**PALM BEACH COUNTY
PLANNING, ZONING AND BUILDING DEPARTMENT
ZONING DIVISION**

Application No.: ZV/DOA-2010-01728
Control No.: 1984-00152
Applicant: Siemens Group, Inc.
Owners: Mizner Trail Golf Club Ltd
Agent: Urban Design Kilday Studios - Wendy Tuma
Telephone No.: (561) 366-1100
Project Manager: Wendy Hernandez, Zoning Manager

TITLE: a Development Order Amendment **REQUEST:** to modify and redesignate uses, and add Pod's (Tracts), units, and access points on the Master Plan.

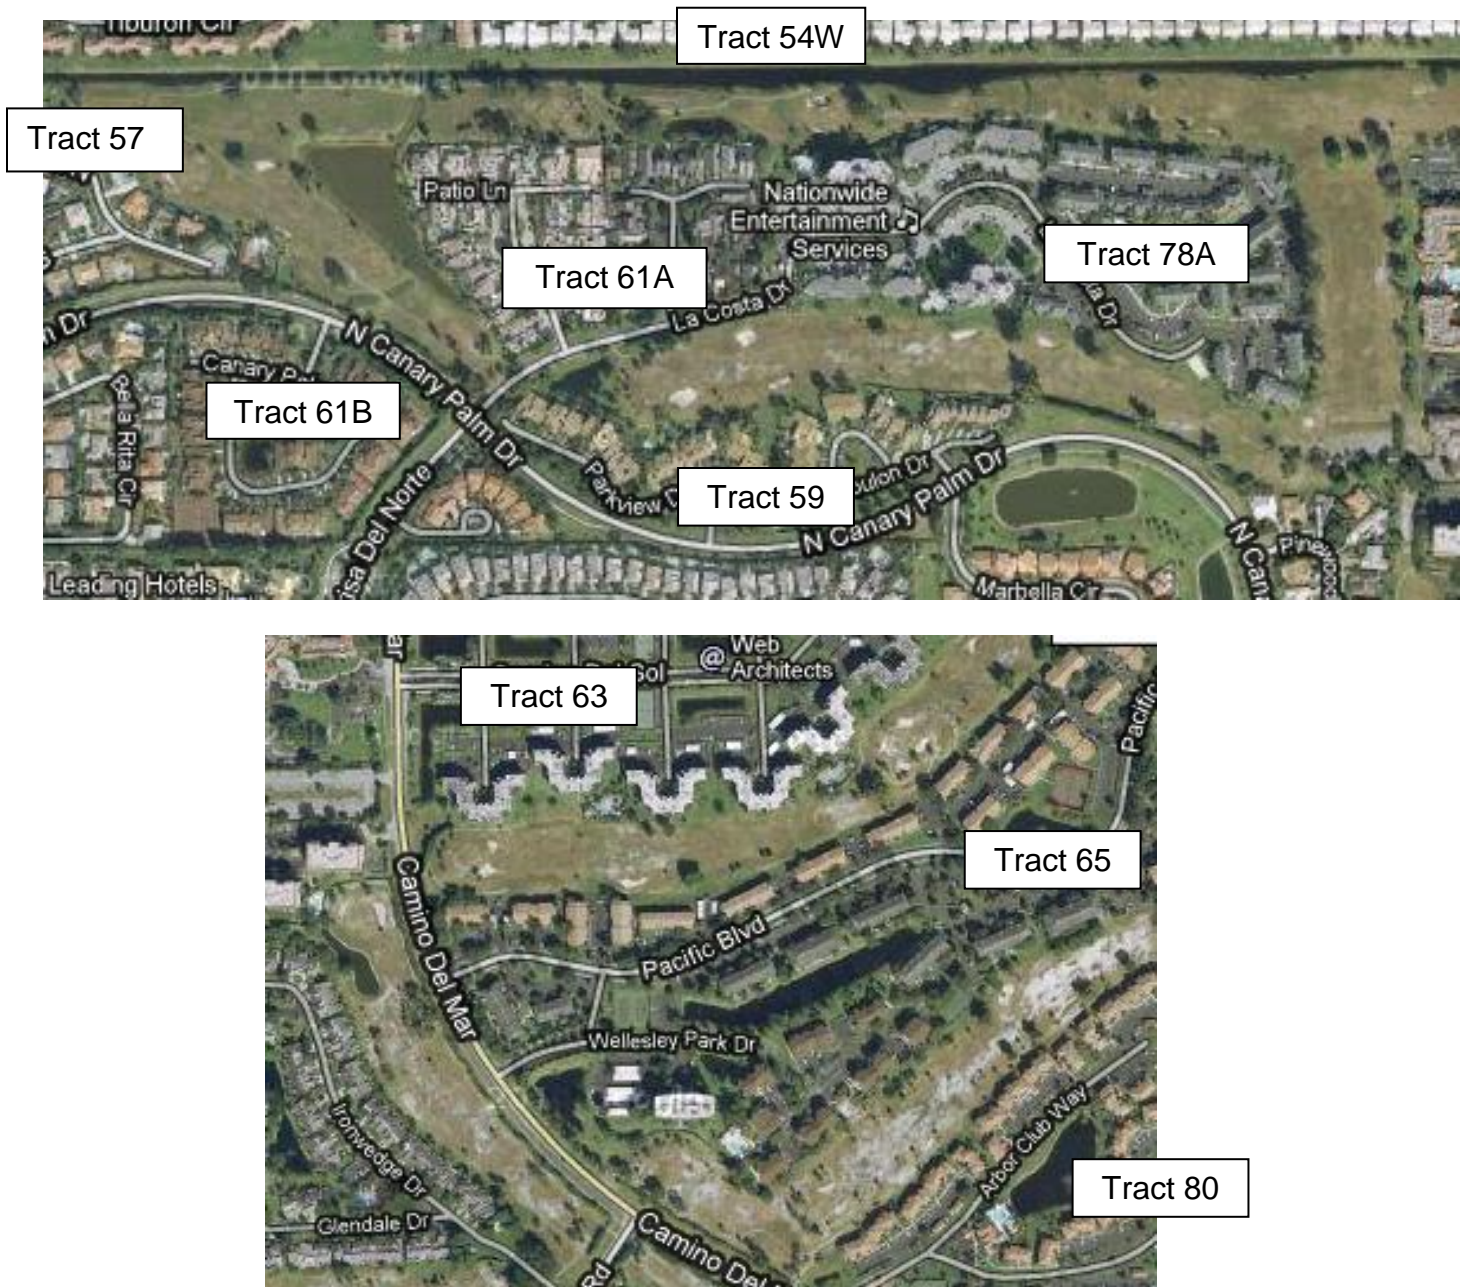
The applicant for Application 2004-826 submitted the Open Space Calculation and Analysis prepared by SPG, Sanders Planning Group, P.A. dated June 28, 2005. According to the study, Boca Del Mar currently provides 644.24-acres of open space located within the residential and park tracts of the PUD and 54.12 acres of civic for a total of 698.36 acres of open space, in accordance with Ordinance 2003-069, as amended through Supplement 8. (This figure does not include the golf courses and clubhouses). The prior applicant was subject to the BCC's direction on golf course conversion and they were required to demonstrate that the conversion of part of the south golf course into residential uses will not result in reduction of open space or recreation. The prior applicant satisfied both the BCC's direction and code requirements.

The BCC's direction of golf conversion was codified in 2006, and the current applicant is subject to the 40% open space dedication (within the affected area) and has proven that the golf course conversion will not result in a decrease of existing opens space/recreational facilities. The current applicant states that (129.89 acres – i.e.126.84 acre of golf course and 3.05 acres of recreation pod), the proposed development will be providing a minimum of 51.96 acres of open space (40%) through the form of landscape buffers, retention, and outdoor recreation facilities as shown on the Preliminary Site Plans (See Figure 9). The provision of this open space would bring the total open space acreage to 750.32 acres.

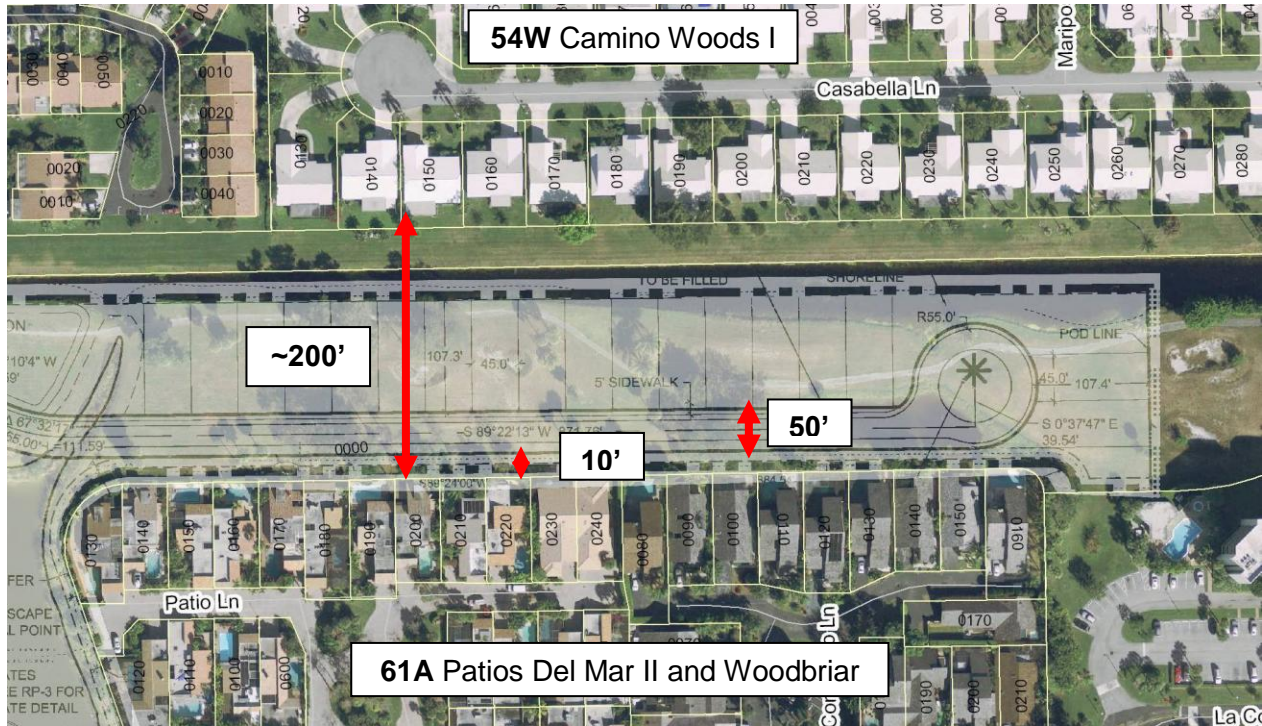
The Preliminary Site and Subdivision plans are provided to show the proposed design of the new residential Tracts (Figure 9). Each of the proposed housing types would be required to meet the minimum property development regulations for the district which are generally:

Many of the homes within the surrounding communities that abut the golf course have minimum setbacks based on the 1969 or 1973 Codes, as amended. The setbacks at that time were measured from roads (30 feet and 60 feet of road widths) and had separations from other residential structures (5 foot per storey per structure). Those units which were constructed adjacent to the golf course would have minimal to no setback. In addition, landscape buffers were intentionally not required in order to maintain the views to this amenity. Under the current code existing structures which do not meet the setback requirements of the current ULDC are considered non-conforming; however, they are vested under Article 1 for information clearly shown on the approved site or subdivision plans.

The current code would require setbacks of 7.5 feet to side property lines and 15 feet for rear property lines for single family homes, providing a minimum separation of 15 feet and 30 feet between two homes. In site planning new developments, the ULDC does not require compatibility buffers between Pods which have the same single-family residential uses. The code does require a minimum width of 10 feet buffers to be provided between single-family and multi-family Pods in order to address compatibility issues between the uses. However, the code is a minimum guideline and does not account for every site situation. The intent of the PDD code is to encourage ingenuity and imagination on the part of design professionals, and it is the responsibility of the applicant to demonstrate how this intent is met. The redevelopment of this master planned golf course affects the layout, function and character of the existing

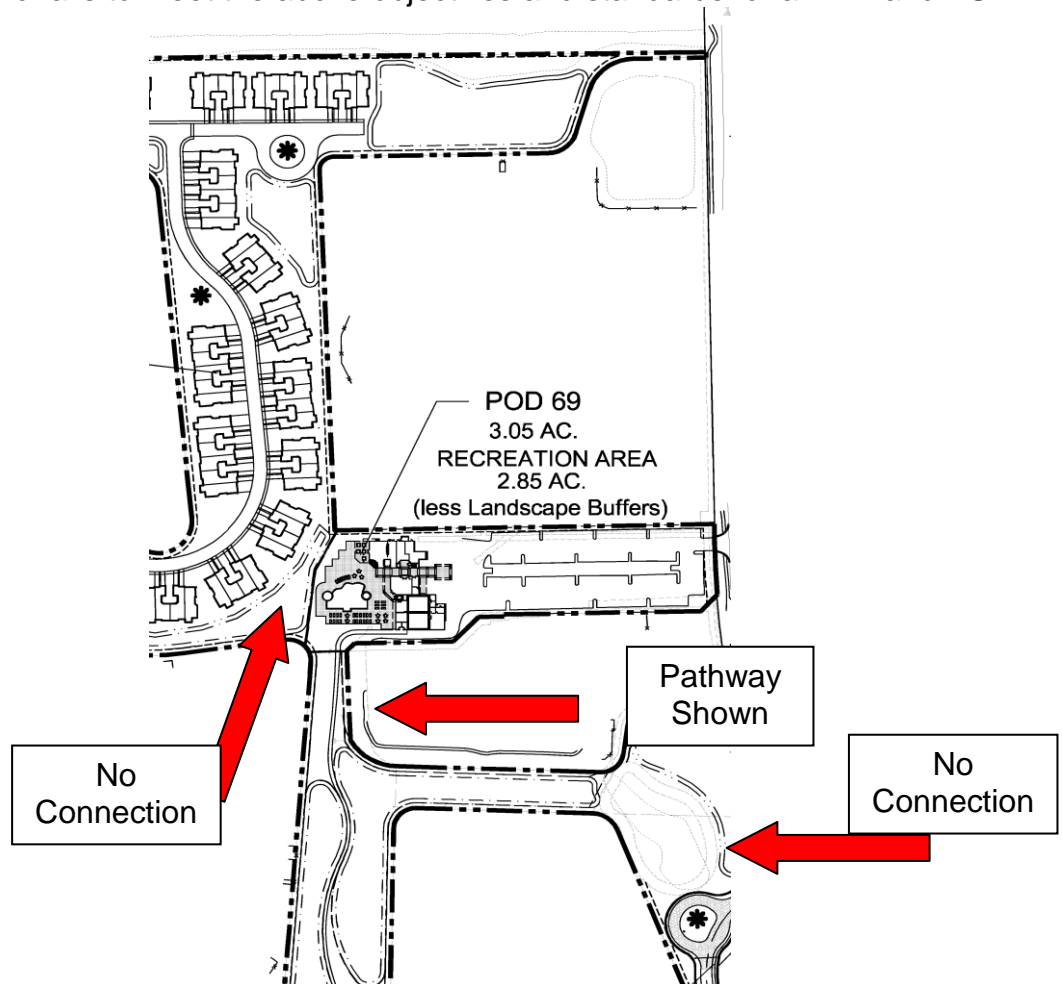
Staff’s analysis focuses on how well the proposed layout of units/amenities/circulation is being integrated into an existing site design.

The graphic above is one example where inter-connectivity is not provided from the adjacent residential tracts to the park and recreation facility. The layout and function of the new tracts do not interrelate to one another as a PUD should be designed with cross connection minimizing access points along existing internal roads. In addition, the proposed access roads serve few residential units due to the narrow configuration of each pod. As seen in the Figure 9, the Preliminary Site/Subdivision Plan and the Figure 10 Visual Impact Analysis, these graphics clearly indicate that the applicant is creating new roads, each of which ends in cul-de-sacs.

On January 28, 2011, the applicant and his agent met with Zoning Division Staff to discuss improved circulation system, providing additional connecting links to establish a more cohesive sidewalk/pathway system between the existing and proposed residential tracts and amenities. Staff indicated that the improved circulation system will be further reviewed at Final Plan Approval by the Development Review Officer contingent upon the approval of the BCC on the development order amendment.
